Addendum No. 3

Project: Expand Long-Term Parking & Realign Terminal Exit Road (Ross Drive)
FWACAA Project No. AF25-01

Date: July 2, 2025

Sheet C6.1.1 and 6.1.2 – Signage Plan – 1 and 2

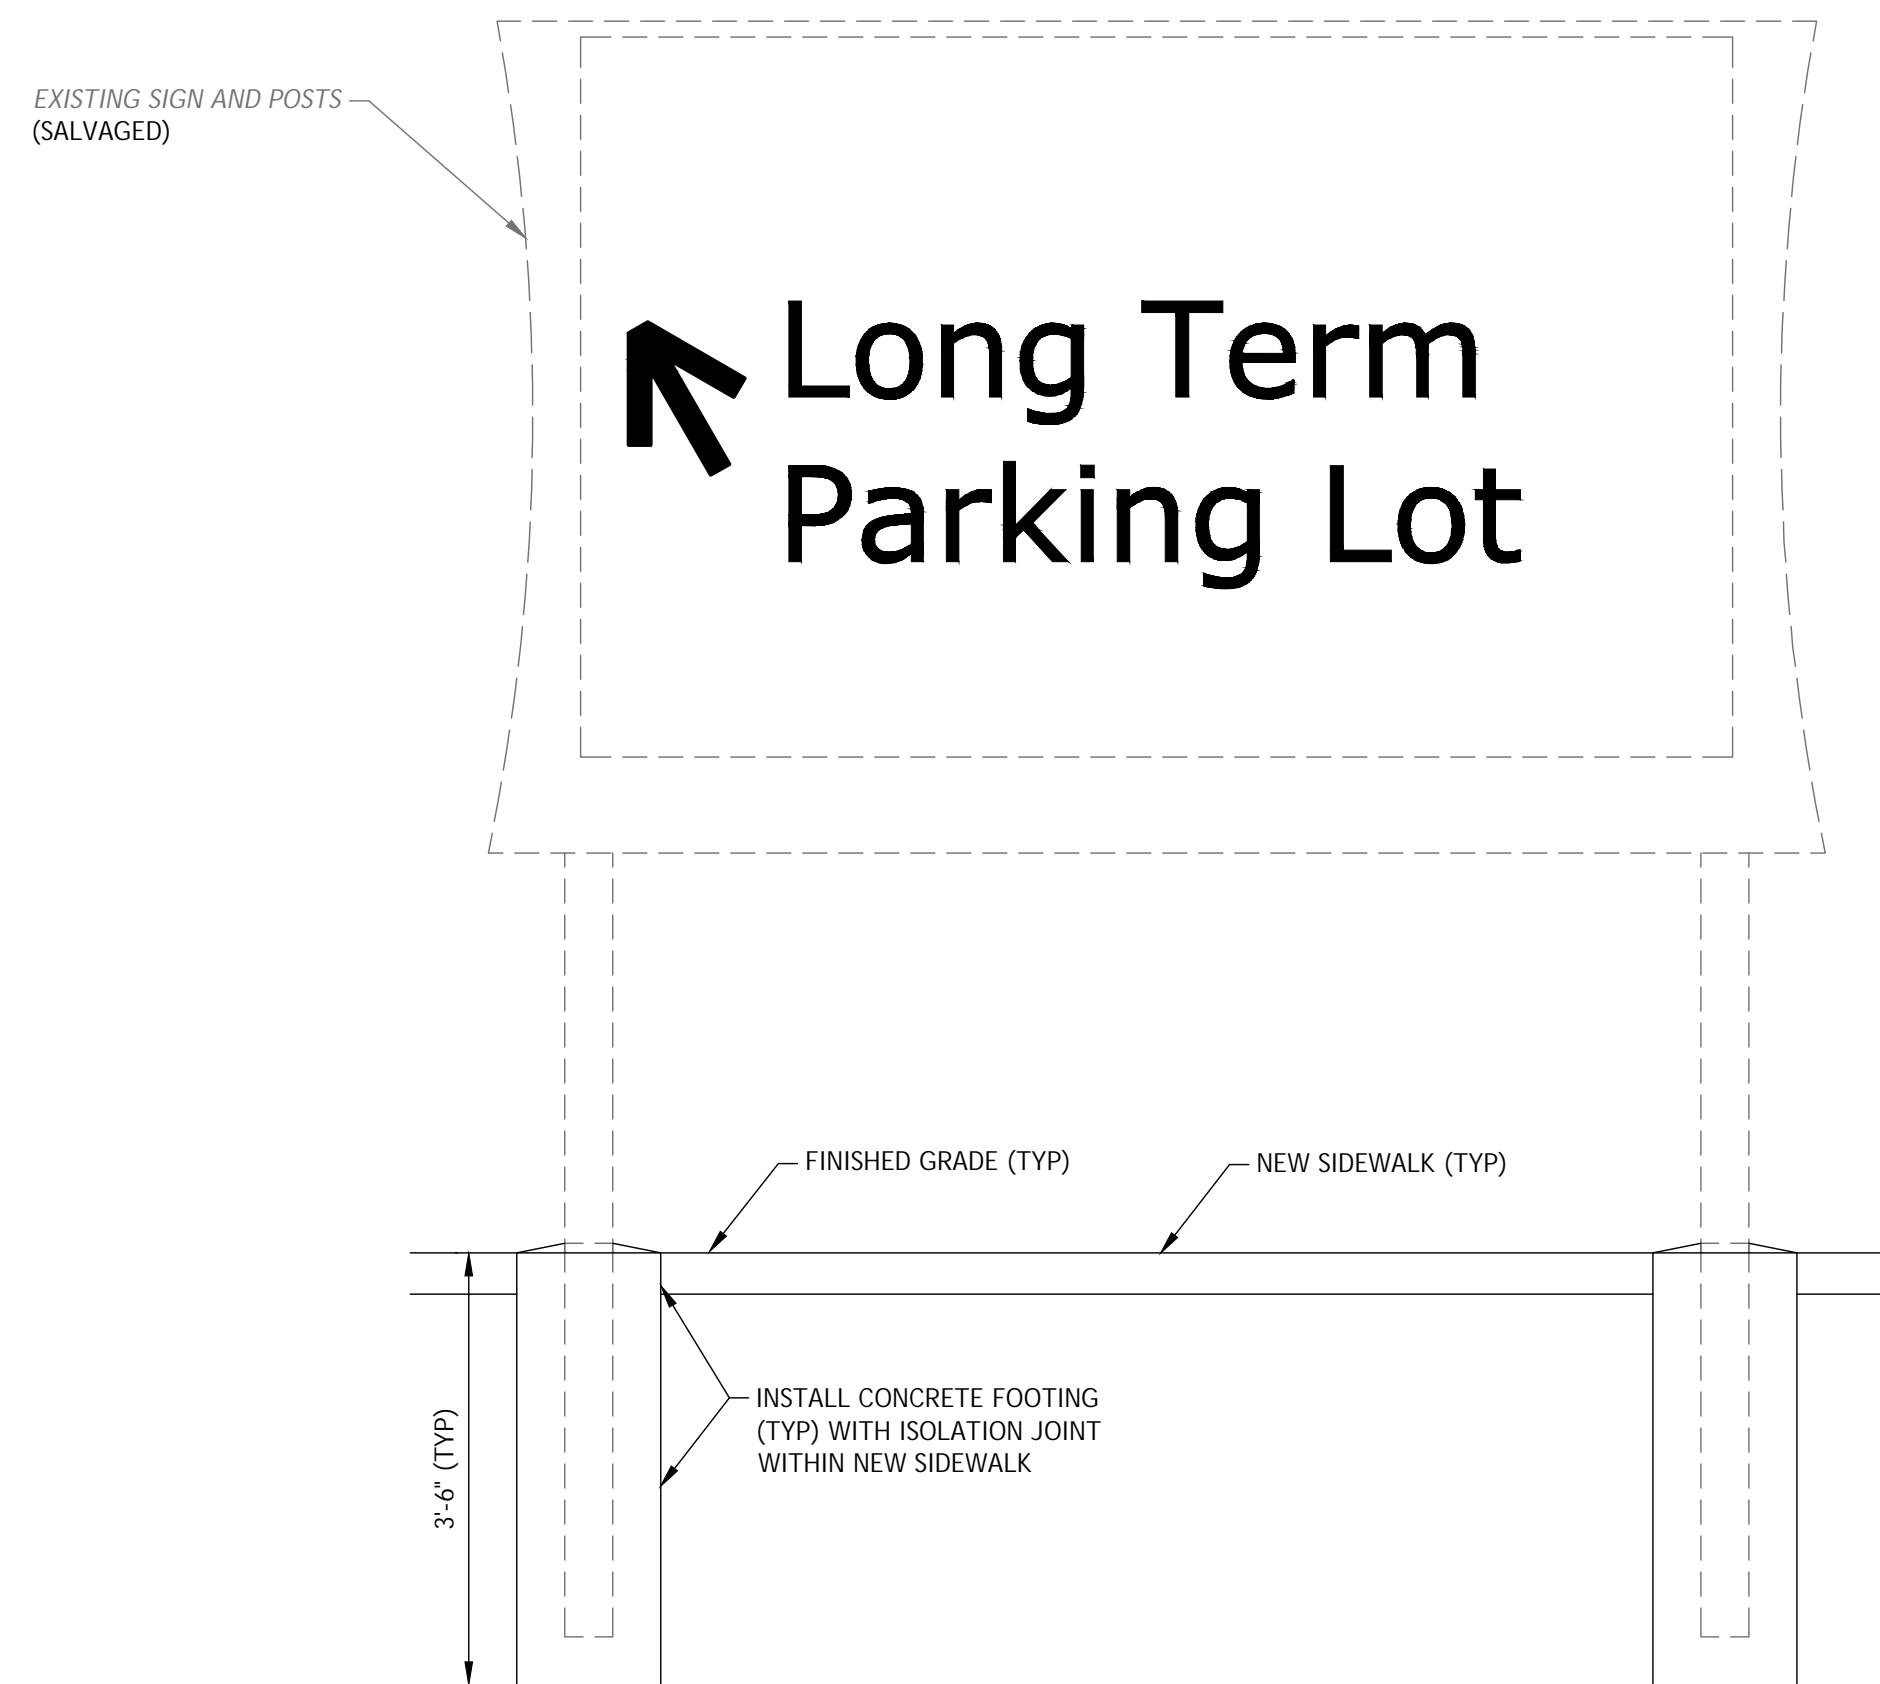
Reissued: This sheet has been reissued with this addendum which includes the following updates and/or revisions:

- Identification of Additive Alternate No. 1 installation of salvaged Sign S-300.
- New Key Note No. 9 added.
- New Signage Note 4 added.
- New plan note referencing Signage Note 4 added.

- Question No. 1 Please clarify what exactly is going on with the ground mounted wayfinding signs. I see 4 noted in the demo plan on D1.1.4 to be removed, refurbished and re-installed. I see only 3 called out to be re-installed on sheet C6.1.2. Bid item #37 only has a quantity of 2 salvaged wayfinding signs to be installed. Sheet C7.2.2 also only shows 3 wayfinding signs.

- Response No. 1 *Three (3) existing Airport Wayfinding signs are to be removed, salvage, refurbished, and reinstalled with this project – two (2) are under the Base Bid (Signs S-100 and S-200), and one (1) is under the Additive Alternate (S-300).*

- Sheet C6.1.2 has been updated and will be reissued with this Addendum.*
- Question No. 2 The notes on sheet C7.2.2 mention that signs are lighted, which they do appear to be. Is the conduit & wire required for this included in the quantity of item 40, 41 and/or 42?

1 SALVAGED SIGN No. S-100 (BASE BID)
LONG TERM LOT SIGN DETAIL
NOT TO SCALE

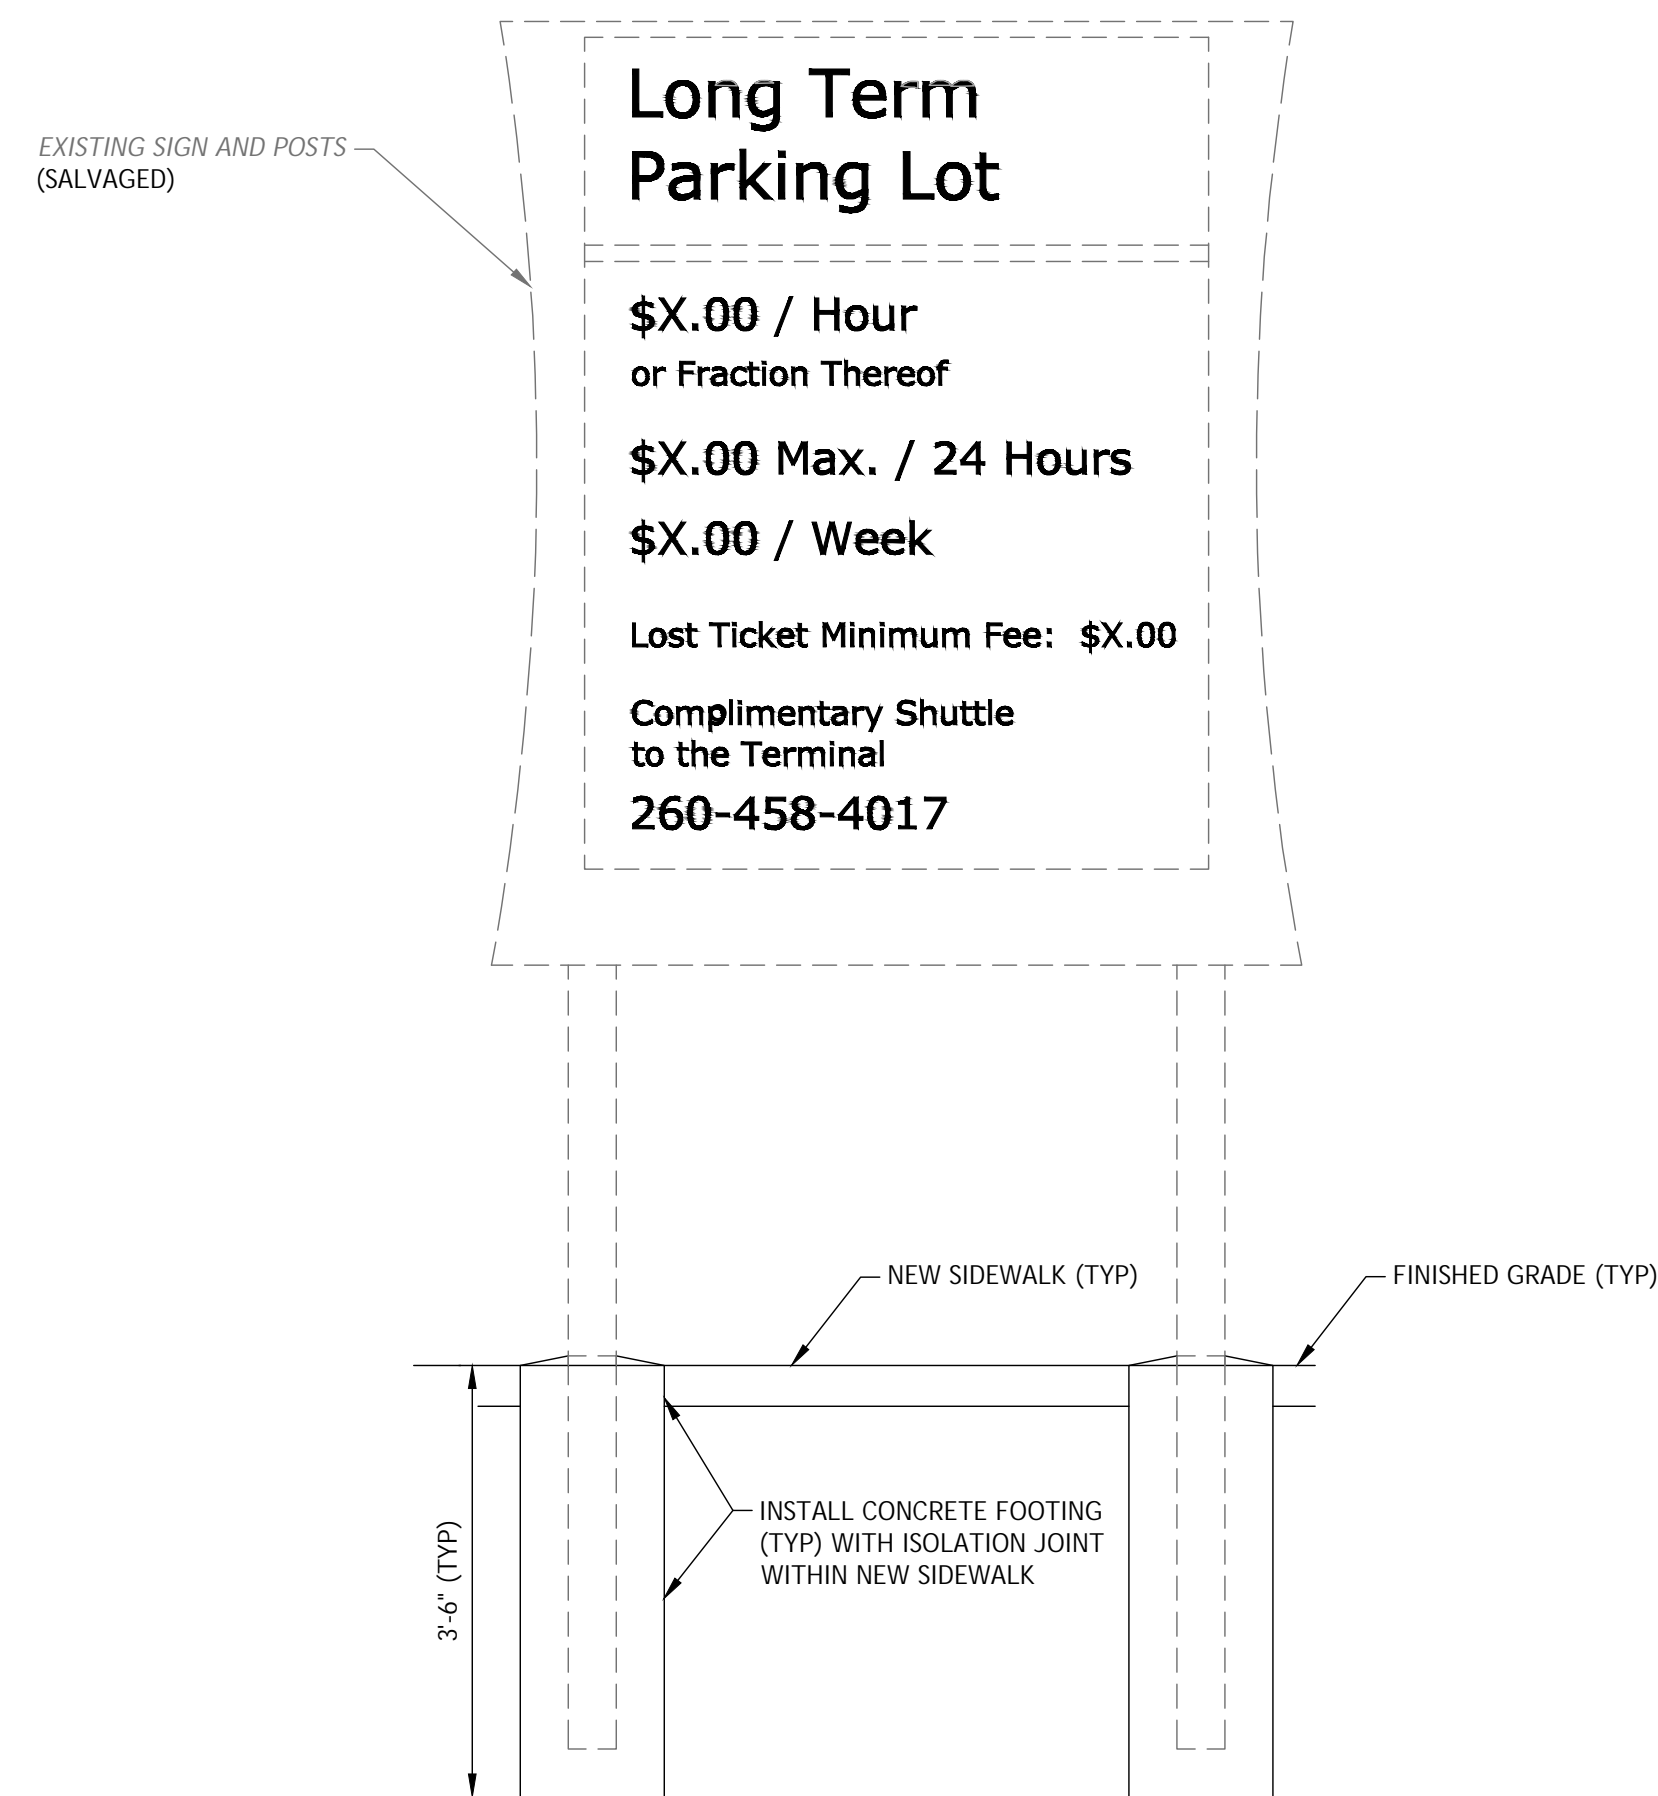
Sheet C7.2.2 – Airport Sign Details

Reissued: Delete this sheet in its entirety and replace with the version enclosed with this Addendum.

- Response No. 3 *See revisions in Item No. 2 noted above for these sheets.*
- Question No. 4 The ground mounted wayfinding signs appear to be directly embedded into the concrete footing. Is the expectation to chip the existing foundations off of the existing posts?

- Response No. 4 *Refer to revisions that have been included with Item No. 2 for Sheet C7.2.2.*
- Question No. 5 Please provide a previous manufacturer of these ground mounted & the pole mounted wayfinding signs. The specs are not 100% for all materials & not any sign company is going to quote the new ones without all of the specifications & it would be best for the original manufacturer to refurbish these.

1. CONTRACTOR SHALL REFURBISH SALVAGED SIGNS IN ACCORDANCE WITH TECHNICAL PROVISION SECTION 02 43 00.
2. SIGN DOWNLIGHTING IS NOT SHOWN BUT IS PRESENT ON THE EXISTING SIGN. CONTRACTOR SHALL INSTALL POWER CABLE AND CONDUIT TO SIGN TO POWER DOWNLIGHTS.
3. CONTRACTOR TO INSTALL NEW CONCRETE FOOTINGS. CONCRETE FOUNDATIONS SHALL BE A MINIMUM OF 12-INCH DIAMETER.
4. WHERE A SALVAGED SIGN IS TO BE INSTALLED WITHIN A NEW SIDEWALK, THE SIGN CONCRETE FOUNDATION SHALL BE ISOLATED FROM THE SIDEWALK WITH PREFORMED EXPANSION JOINT MATERIAL.
